Access Compliance Report

Public Rights-of-Way

(Curb Ramps)

Intersection ID: 31717	Main Street: MOSSYCUP_DR	Cross Street: PLOWDON_CT	Location: NW
ADA ID: 825FA9CEF71F	Ramp Type: PerpDiag	Initial Pass/Fail: Fail	Overall Compliance: No
		Severity Score: 12.5

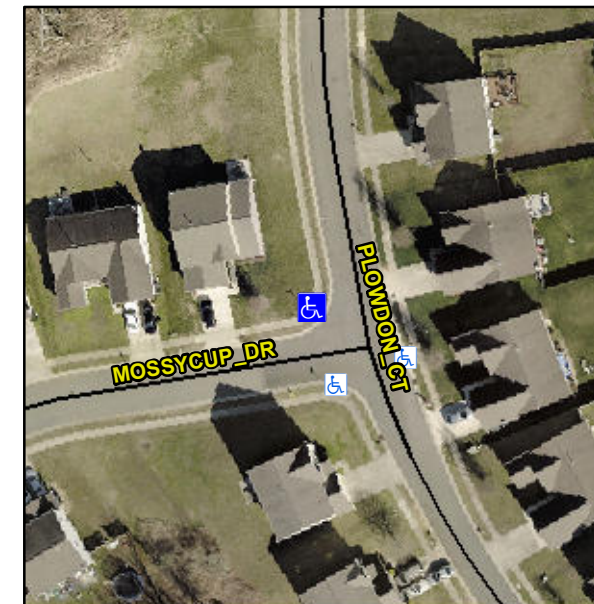
Not Found, R304.2.2

Compliance	Description	Data	Compliance	Description	Data
N/A	Ramp Length (in)	47.5	No	Ramp Slope (%)	10.5
Yes	Ramp Width (in)	48.0	Yes	Ramp XSlope (%)	0.5
N/A	Flare Type LT	N/A	N/A	Flare Type RT	N/A
N/A	Flare Slope LT (%)	N/A	N/A	Flare Slope RT (%)	N/A
N/A	Flare Traversable LT?	N/A	N/A	Flare Traversable RT?	N/A
N/A	Landing Length (in)	N/A	N/A	DWS Provided?	N/A
N/A	Landing Width (in)	N/A	N/A	DWS Contrast?	N/A
N/A	Landing Slope (%)	N/A	N/A	DWS Length (in)	N/A
N/A	Landing X Slope (%)	N/A	N/A	DWS Full Width?	N/A
N/A	Landing Curb? (Y/N)	N/A	N/A	DWS Offset (in)	N/A
N/A	Shared Landing?	N/A			
N/A	Gutter Ponding?	N/A	N/A	Gutter Slope (%)	N/A
N/A	Gutter Lip Ht (in)	N/A	N/A	Gutter X Slope (%)	N/A
N/A	Painted X Walk1?	No	N/A	Painted X Walk2?	No
	X Walk 1 Direction	To S		X Walk 2 Direction	To E
N/A	X Walk 1 Width (in)	N/A	N/A	X Walk 2 Width (in)	N/A
	X Walk 1 Slope (%)	3.5		X Walk 2 Slope (%)	4.9
	X Walk 1 X Slope (%)	4.1		X Walk 2 X Slope (%)	6.4

Remove & Replace Curb Ramp With Two New Directional Ramps or Equivalent.
